Addendum No. 1

Project Name: N5001(1)1,2&4 Road Improvement Project in Toadlena/Two Grey Hills, NM

Owner: Navajo Division of Transportation

3. Plans: Sheets 98-102 have been revised to clarify dimensions for Bridge N213 per question received. Replace plan sheets 98-102 and refer to the question-and-answer section.

DETAIL A
(GRS, beam seat, bearing bed zone, and integrated approach detail)
NO SCALE

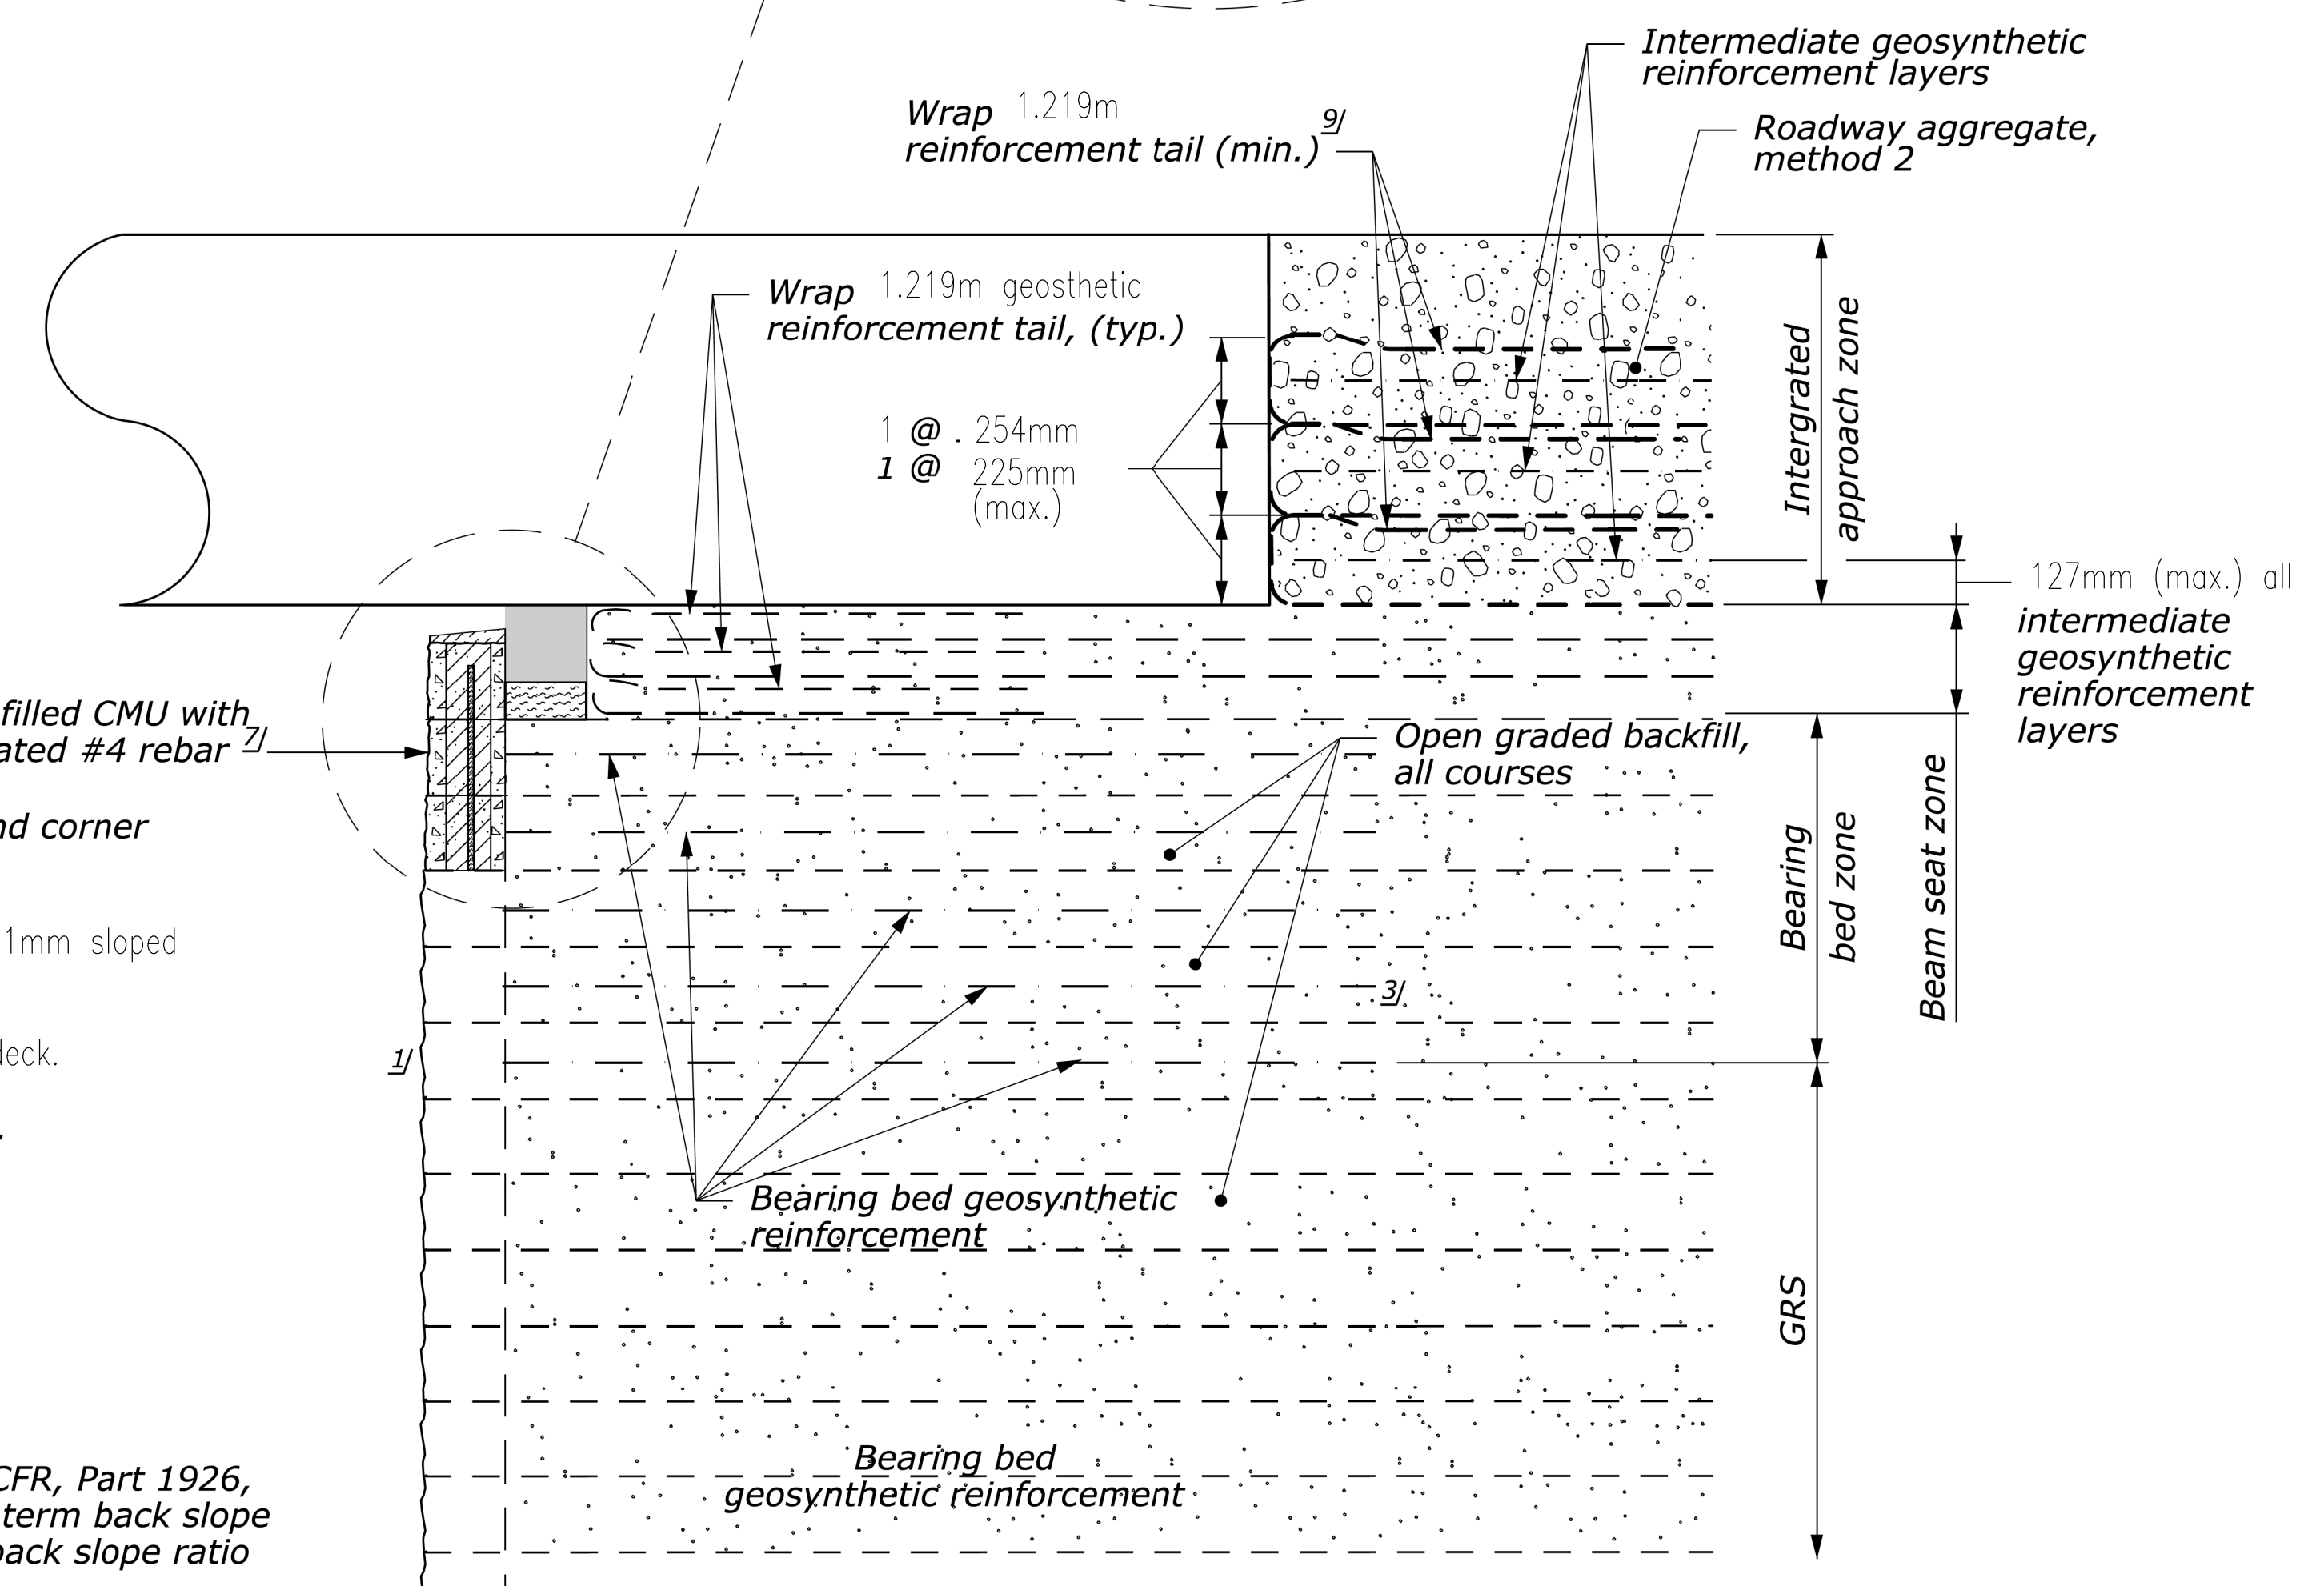
<p>Will the department please verify the dimensions of the concrete leveling pad on structure 213. Plan sheet 99 is showing a width of 2.820 Meters. Additionally, the height of the leveling pad is referenced as</p>	<p>The depth of the leveling pad is to be 0.203m minimum to 0.500m maximum. The width of the leveling pad is to be 0.457m.</p>

.203 M on sheet 99 and on sheet 98 it is referenced as 500 MM max.	Plan sheets 98 thru 101 have been revised to reflect these dimension clarifications.
Will the department please provide a breakdown of the items that are to be paid for under bid item 20304-1000 (Removal of structures and Obstructions).	See the attached table of items that are to be included in Bid Item 20304-1000 Removal of Structures and Obstructions.
Note 8 (Removal of Existing Bridge) on plan sheet 93 of the project plans states that the contractor shall remove, clean and stockpile all existing salvageable material. Will the department please provide a list of the material that is to be salvaged for both bridges.	Contractor is not to salvage any of the bridge components. Contractor to remove and dispose of all existing bridge components. Please reference Plan Sheet 3, General Note 20 for additional direction on salvageable items.

GRS-IBS-DETAILS
SHEET 3 OF 4

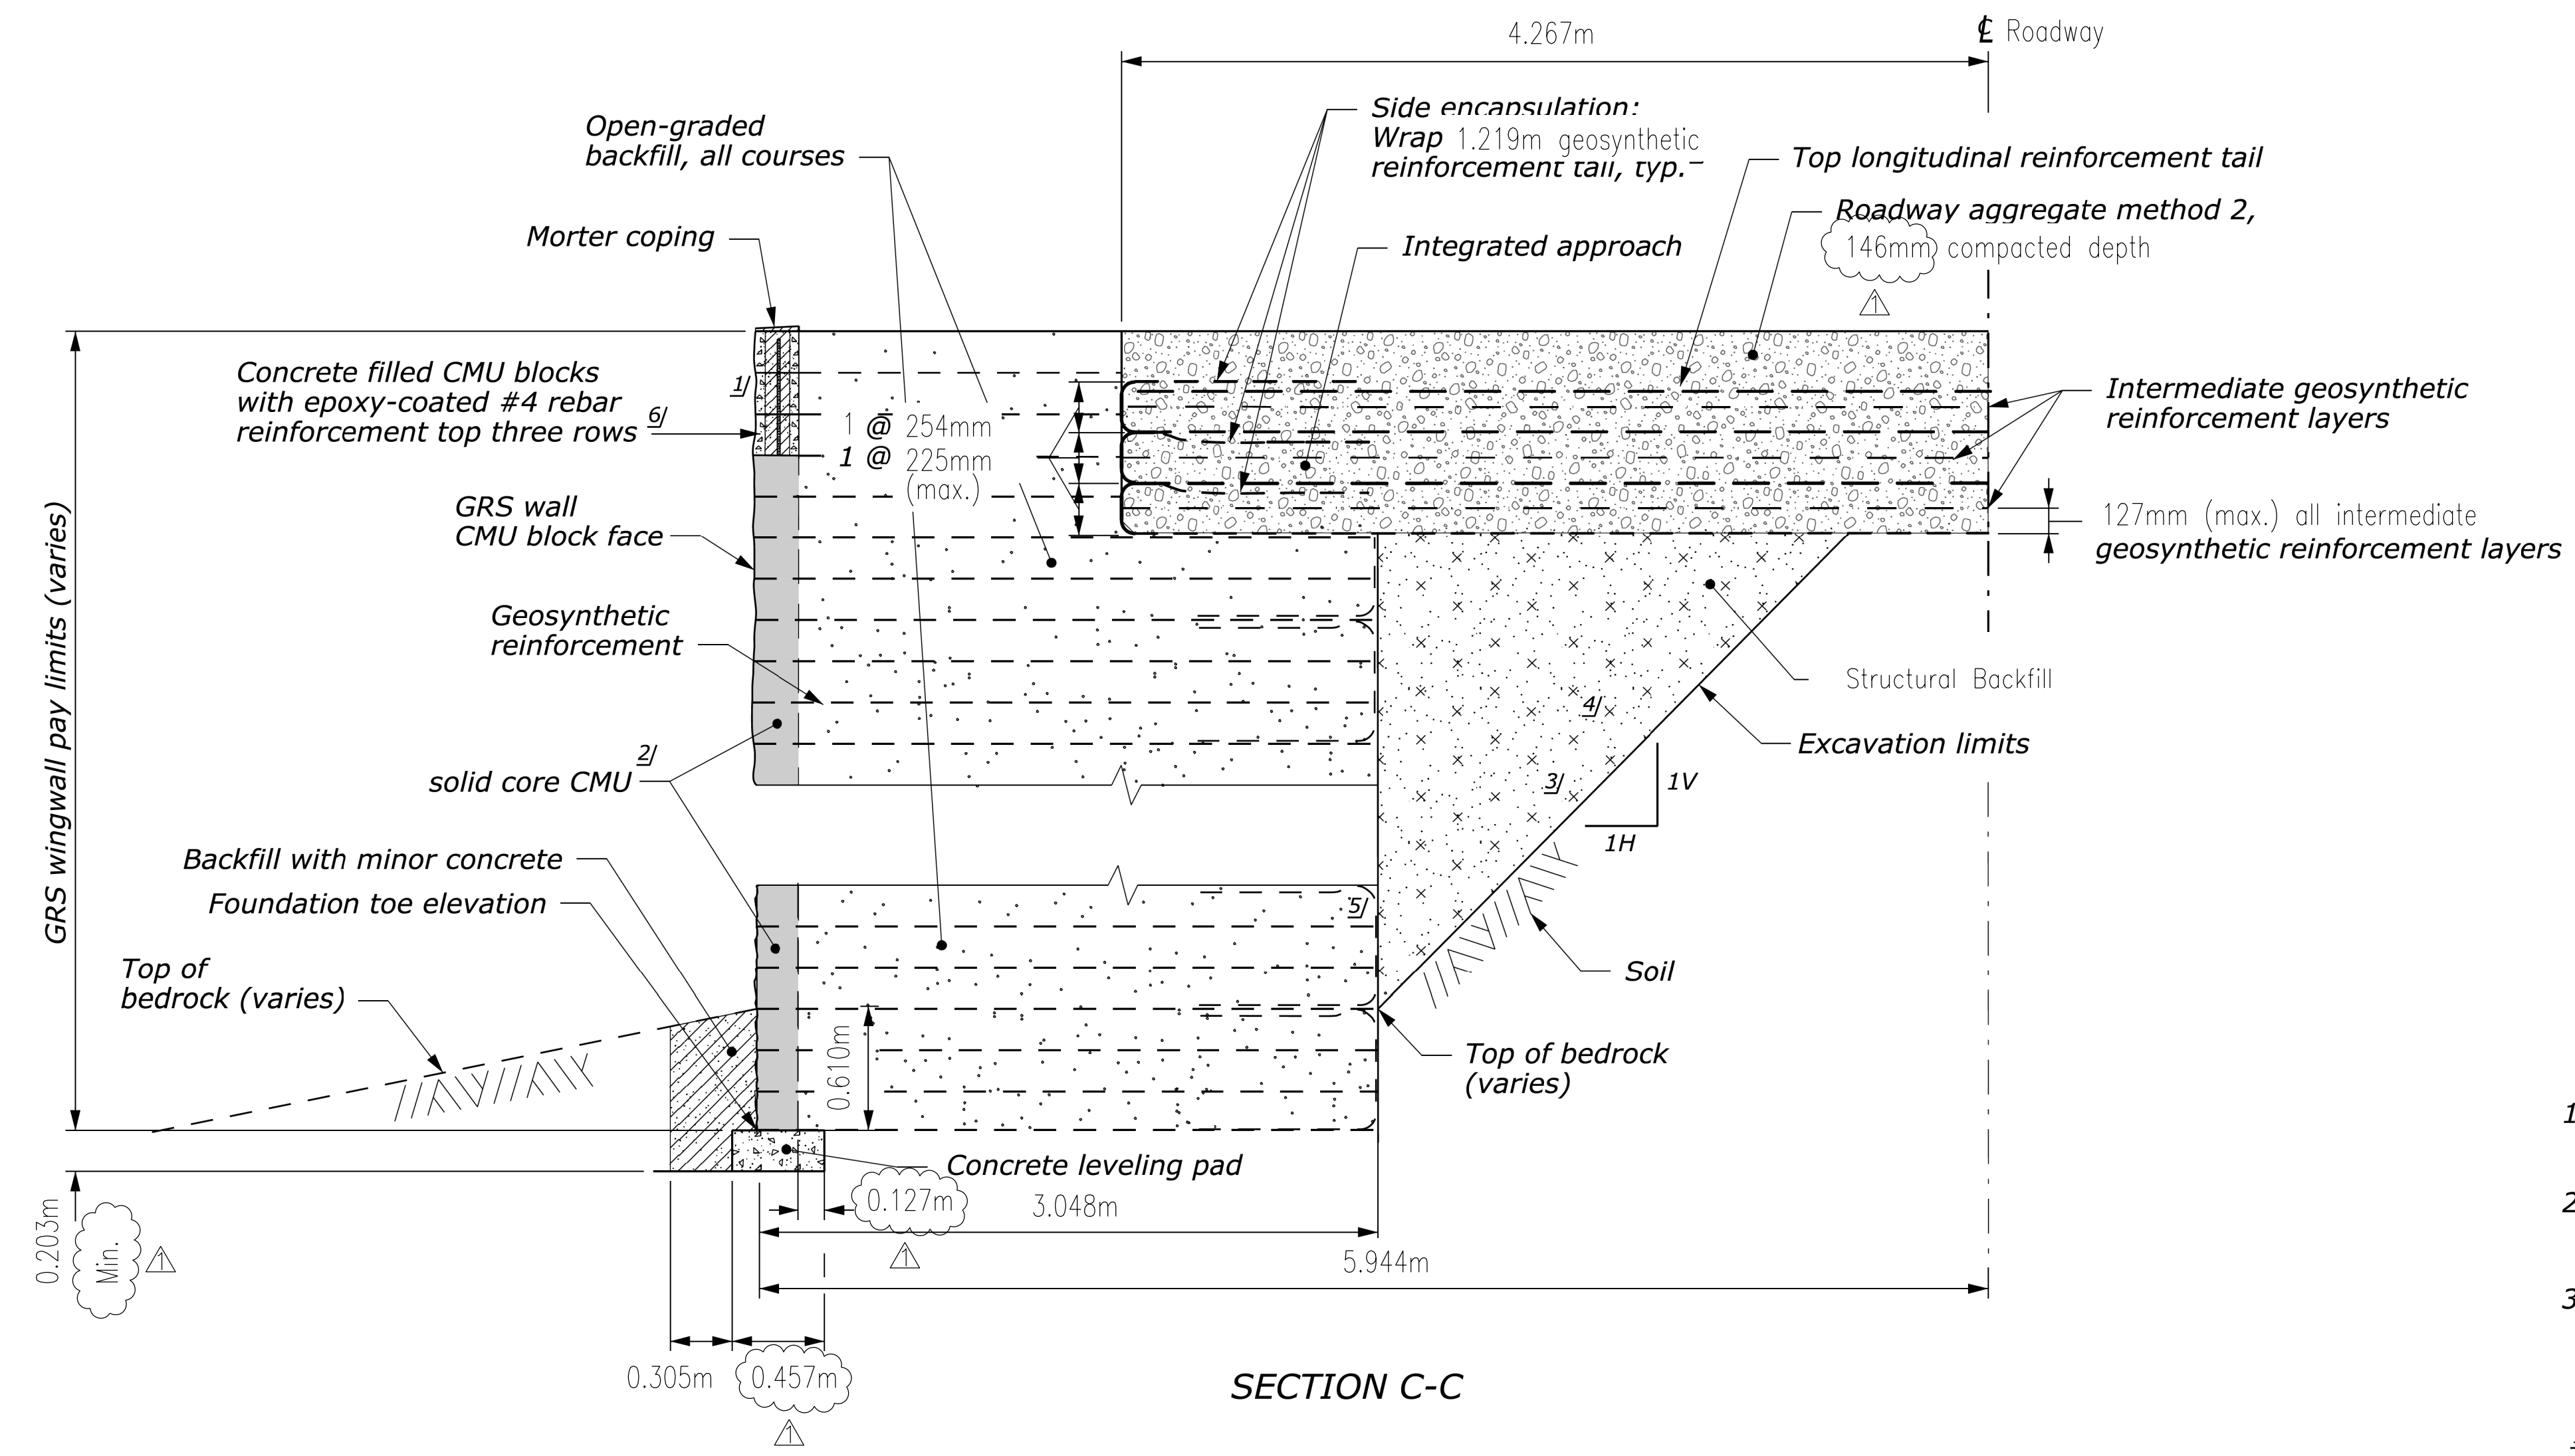
Under Part III-Outline of Request of Proposal, Section B.-Qualifications And Capability, part "e" requires the firm that is providing the proposal to provide documentation showing they are properly licensed or registered in the State of AZ. This project is located in NM, does this requirement still apply?	No. Licenses and registrations for the State of Arizona are not required. This requirement should be New Mexico . The Request for Proposal language was corrected to reflect this clarification.
How will the geosynthetic in the integrated approach slab be paid for on plan sheet 102?	The geosynthetic in the integrated approach slab is to be paid under bid item number 57401-0000, GRS-IBS, Geosynthetic Reinforcement.
Will the department please clarify the dimensions for the integrated approach slabs. Section C-C on plan sheets 101 & 102 have different dimensions listed for the same drawing.	Integrated approach slab shall have 146 mm roadway aggregate over the GRS reinforcement. Plan sheets 101 & 102 have been revised to reflect this change.
